PREVOST

Warranty Bulletin

95-37

Date: **November 1995**
Section: **05**
Subject: **MODIFICATION TO RADIATOR FAN CLUTCH CIRCUIT**
Application:

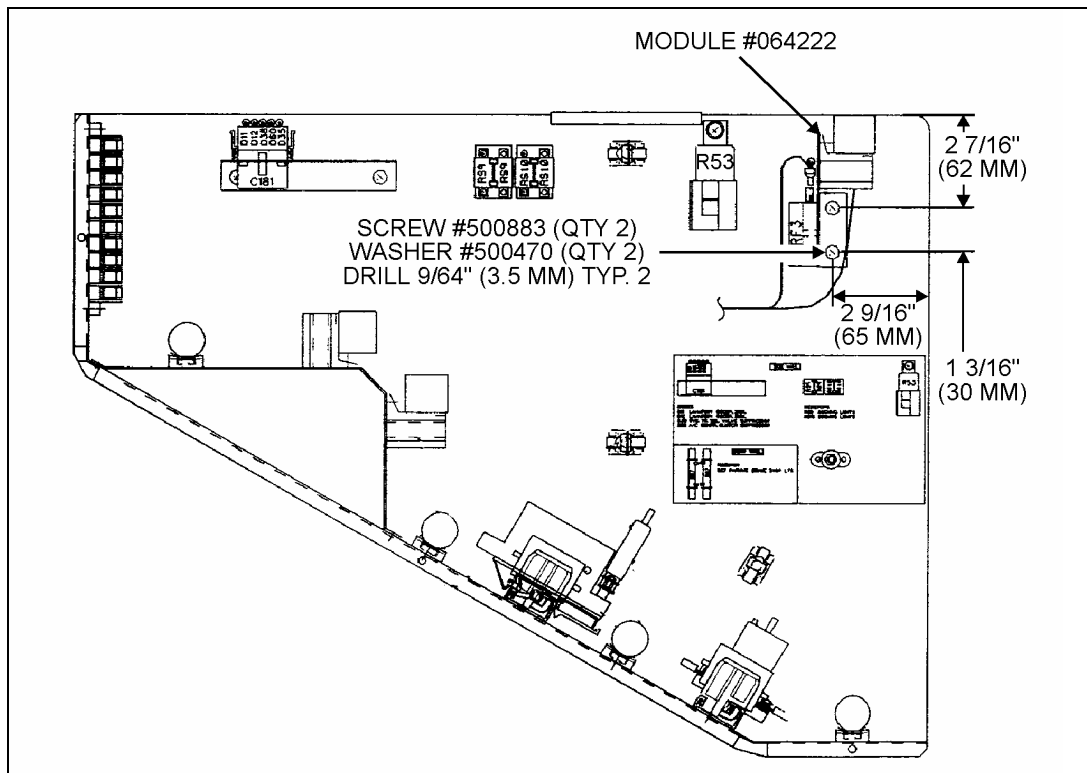
1. Open rear electric compartment door located on L.H. side of vehicle.
2. Locate mounting panel fixed inside compartment on R.H. wall, position fan control module #064222 as illustrated in figure 1, then mark position of the two holes to be drilled.
3. Drill two holes using a 9/64" (3.5 mm) diameter bit.

4. Fix fan control module to mounting panel using two Phillips head screws #500883 and lock washers #500470.

FIGURE 3

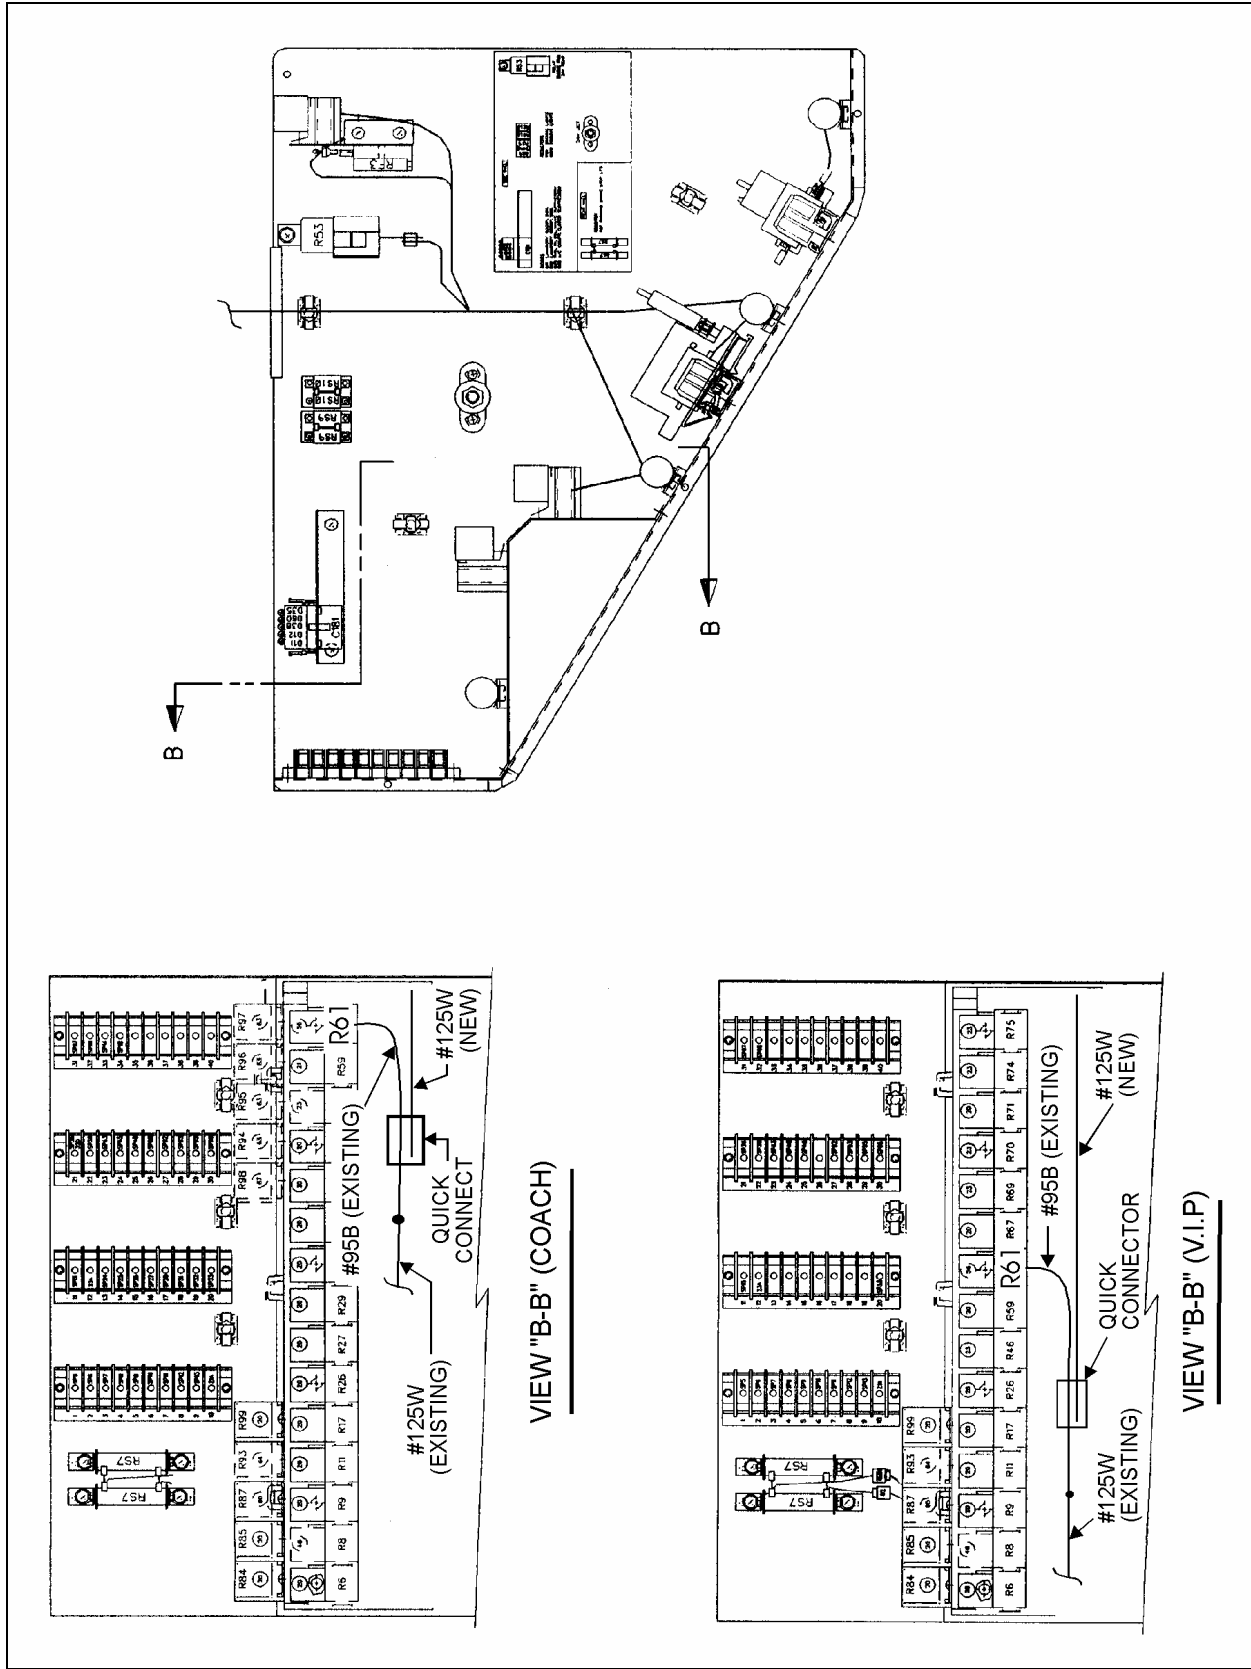
-
5. Identify on wires provided with fan control module, the red wires #291 and #292. Route these wires up to white connector C414. Tap wire #291 with connector C414's wire #291 using quick connector #560710. Repeat for wires #292. See figure 2 (page 3).

6. Identify on wires provided with fan control module, the red wire #85, cut this wire near ring terminal, discard terminal, then route wire up to relay base R53. Tap wire #85 with relay base R53's wire #85 using quick connector #560710. See figure 2.
7. Identify on wires provided with fan control module, the black wire #OR, route this wire up to negative post identified "N", then connect to this post. See view "A-A" in figure 2.
8. Identify on wires provided with fan control module, the black wire #125W, route this wire up to relay base R61 then tap wire #125W with relay base R61's wire #95B using quick connector #560710. See the appropriate view "B-B" in figure 3 (page 4).

Note: *Wire #95B becomes wire #125W at a connection located only a few inches away from relay base R61. Consequently, new wire #125W can be connected to existing wire #125W, if preferred.*

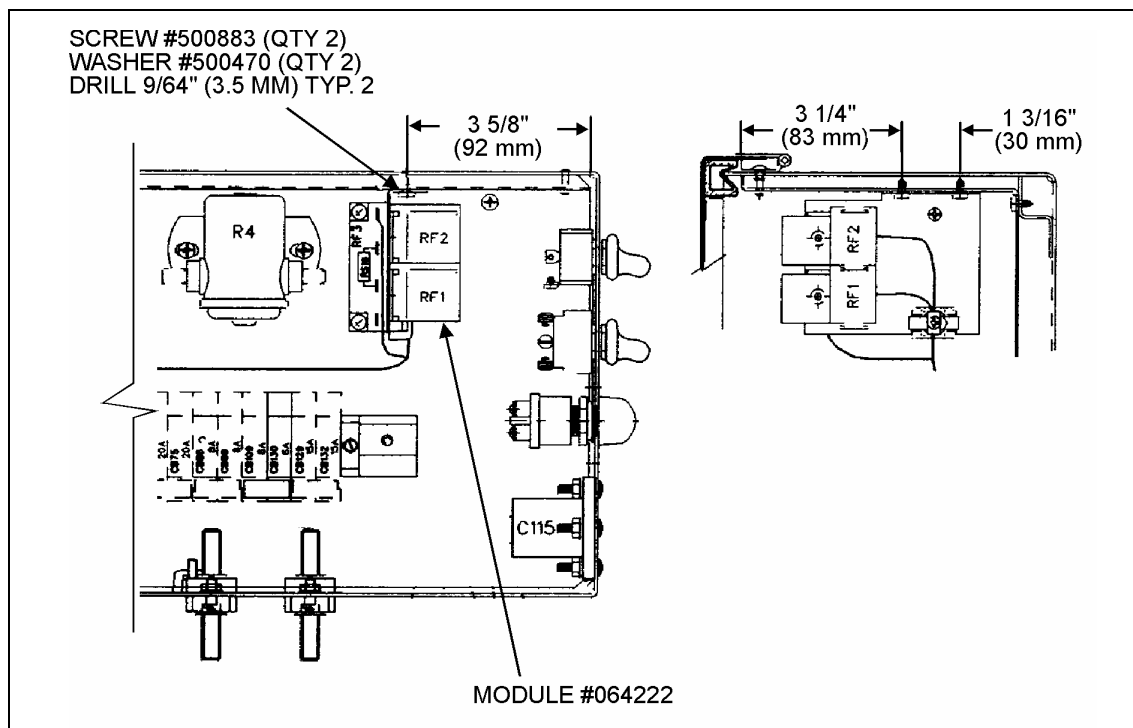
1. Open engine compartment rear doors, locate electric junction box, then open panel.
2. Position fan control module #064222 as illustrated in figure 4, then mark position of the two holes to be drilled.
3. Drill two holes using a 9/64" (3.5 mm) diameter bit.

4. Fix fan control module to mounting panel using two Phillips head screws #500883 and lock washers #500470.

FIGURE 5

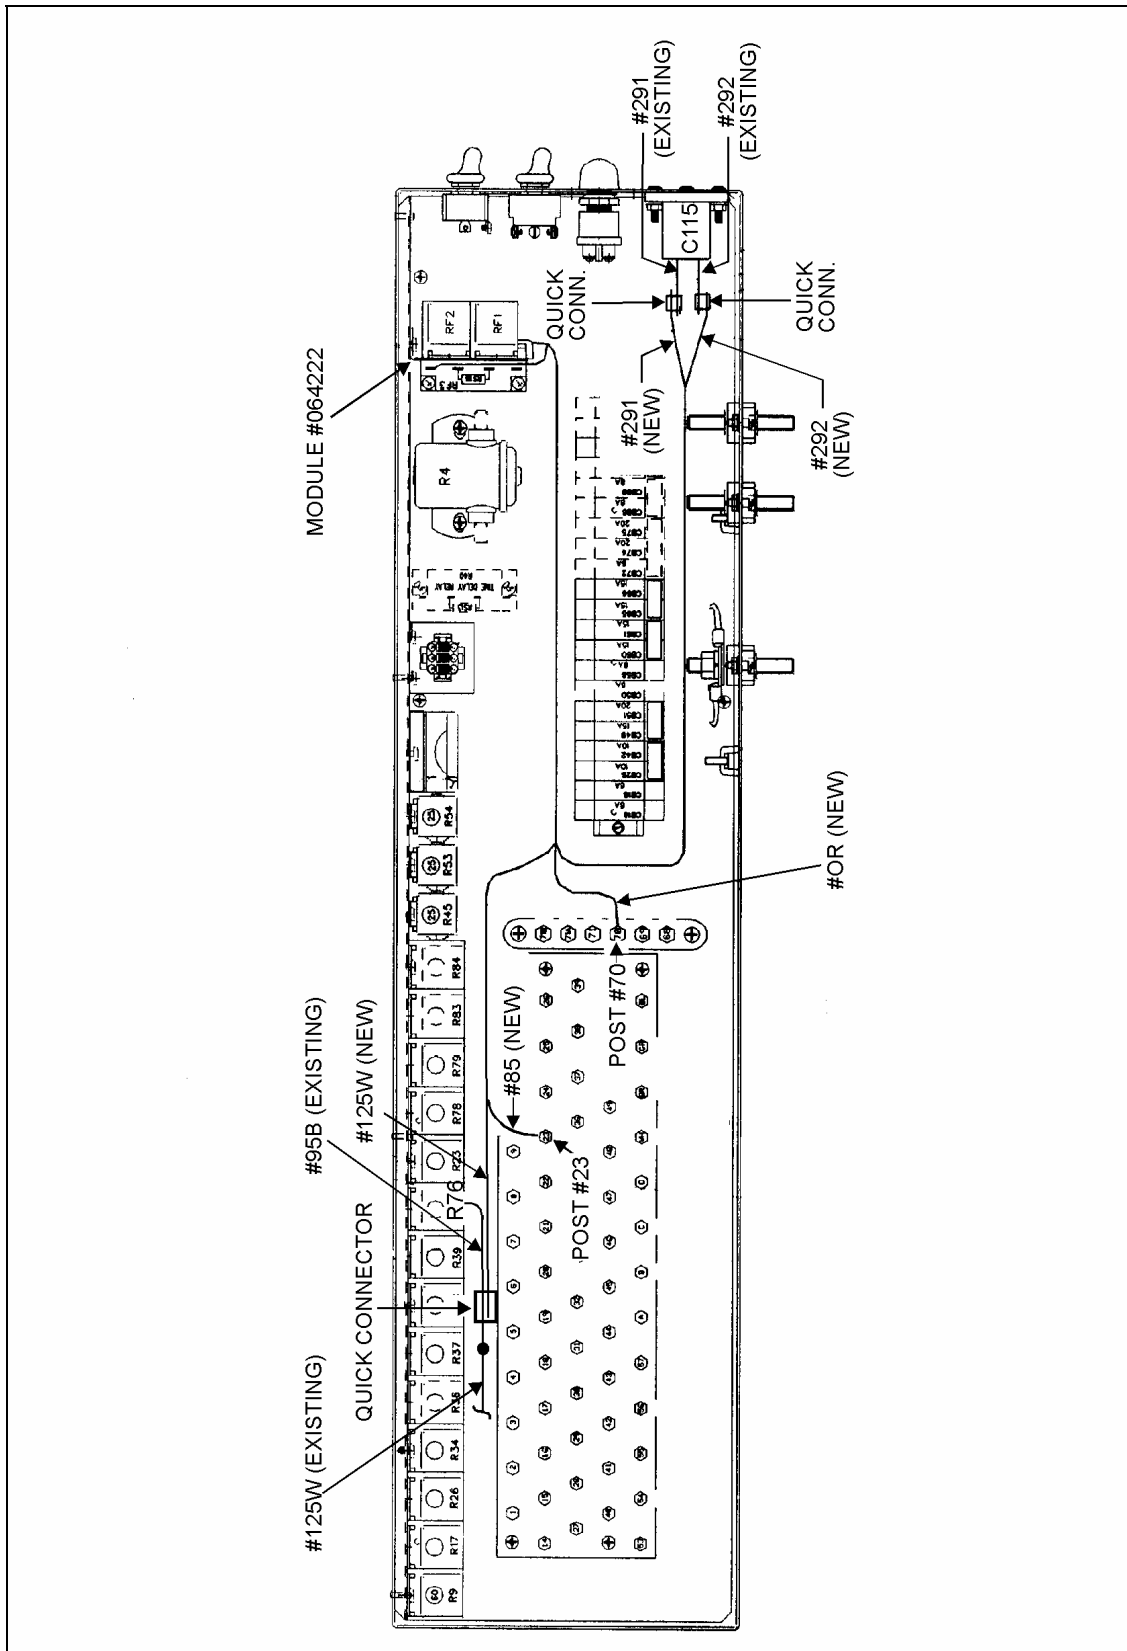
-
5. Identify on wires provided with fan control module, the red wires #291 and #292. Route these wires up to connector C115 following existing harnesses (see fig. 5, page 7). Tap wire #291 with connector C115's wire #291 using quick connector #560710. Repeat for wires #292.
 6. Identify on wires provided with fan control module, the red wire #85, route this wire up to post #23 then connect to this post.
 7. Identify on wires provided with fan control module, the black wire #OR, route this wire up to post #70 then connect to this post.
 8. Identify on wires provided with fan control module, the black wire #125W, route this wire up to relay base R76 then tap wire #125W with relay base R76's wire #95B using quick connector #560710.

Note: Wire #95B becomes wire #125W at a connection located only a few inches away from relay base R76. Consequently, new wire #125W can be connected to existing wire #125W, if preferred.

FIGURE 6

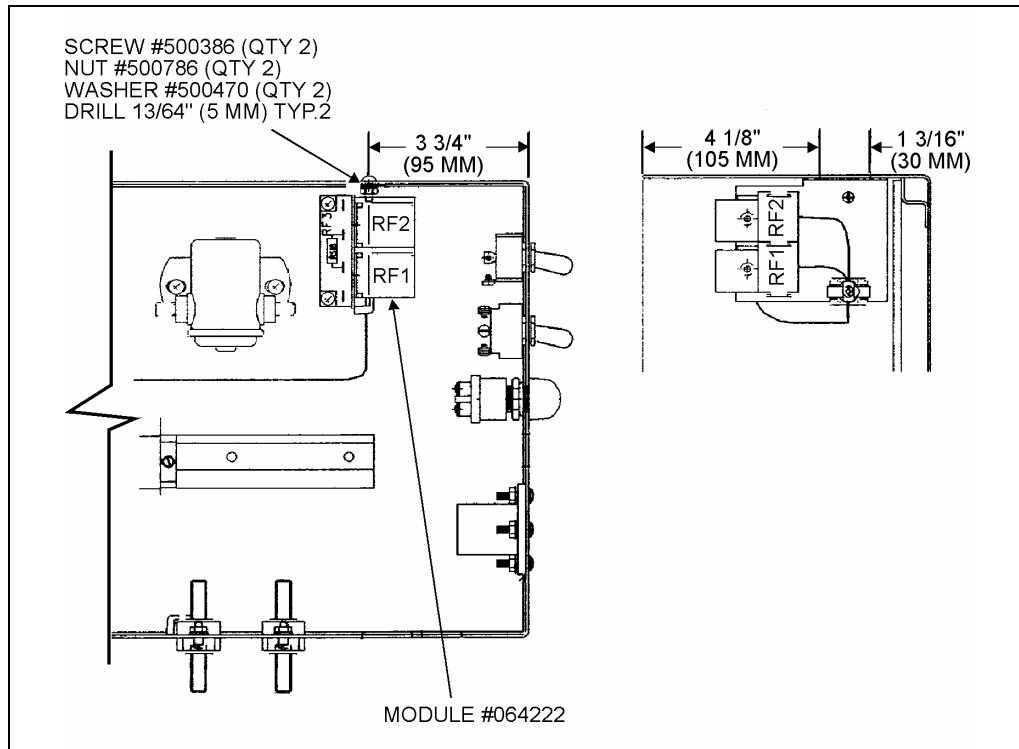
1. Open engine compartment rear doors, locate electric junction box, then open panel.
2. Position fan control module #064222 as illustrated in figure 6, then mark position of the two holes to be drilled.
3. Drill two holes using a 13/64" (5 mm) diameter bit.
4. Fix fan control module to junction box using two Phillips head screws #500386, lock washers #500470 and hexagonal nuts #500786.

FIGURE 7

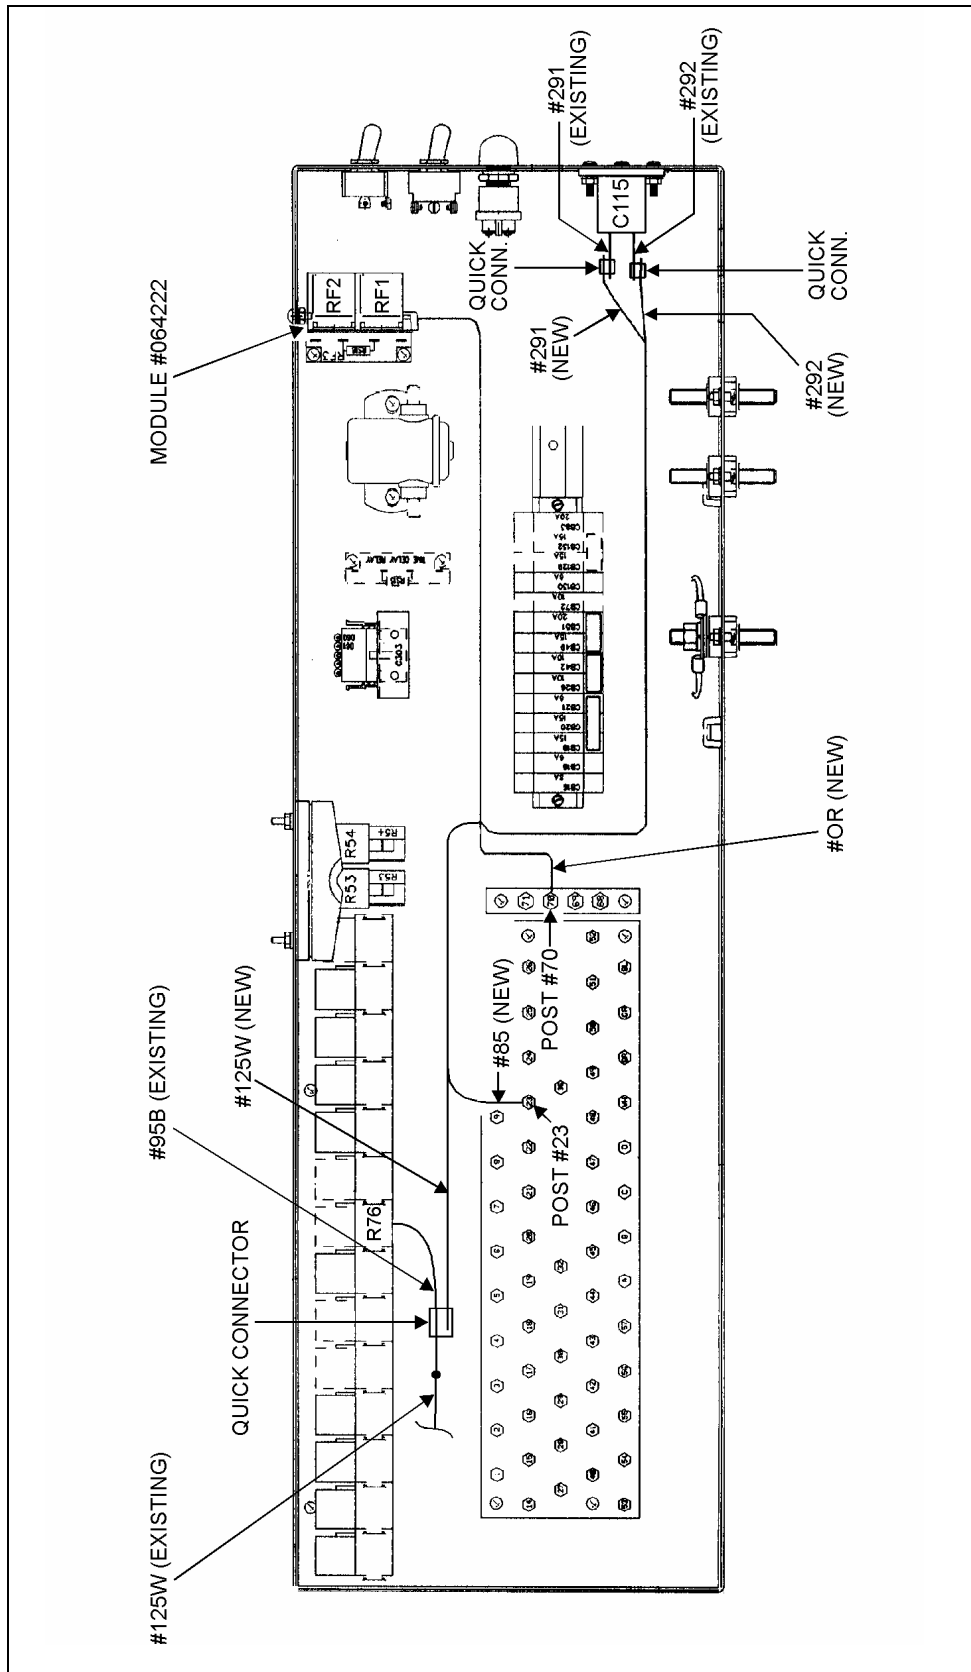
-
5. Identify on wires provided with fan control module, the red wires #291 and #292. Route these wires up to connector C115 following existing harnesses (see fig. 7, page 10). Tap wire #291 with connector C115's wire #291 using quick connector #560710. Repeat for wires #292..
 6. Identify on wires provided with fan control module, the red wire #85, route this wire up to post #23 then connect to this post.
 7. Identify on wires provided with fan control module, the black wire #OR, route this wire up to post #70 then connect to this post.
 8. Identify on wires provided with fan control module, the black wire #125W, route this wire up to relay base R76 then tap wire #125W with relay base R76's wire #95B using quick connector #560710.

Note: *Wire #95B becomes wire #125W at a connection located only a few inches away from relay base R76. Consequently, new wire #125W can be connected to existing wire #125W, if preferred.*
